Access Compliance Report Public Rights-of-Way (RR Crossings)

Intersection ID: 10025412	Main Street: E_CARSON_BV	Location: N/A
ADA ID: D37DBCE0857A	Overall Compliance: No	Severity Score: 0.0
Codes/Mitigation Info/Possible Solution		Field Measurements/Component Compliance

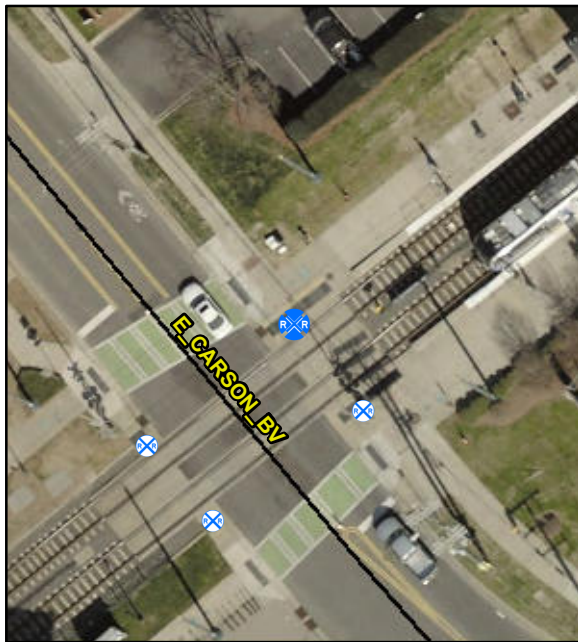
**Remove & Replace Detectable
Warning System. Provide Pedestrian
Gate. Remove & Replace Walking
Surface Adjacent to Rail.**

Compliance	Description	Data
Yes	DWS Provided?	Yes
Yes	DWS Contrast?	Yes
Yes	DWS Width (in)	Yes
Yes	DWS Length (in)	36.0
No	DWS Offset (in)	29.0
No	Pedestrian Gate?	No
N/A	DWS Outside Gate?	No
N/A	Rail Type?	LightRail
No	Flangeway Gap (in)	3.0
Yes	Sidewalk Width (in)	73.0
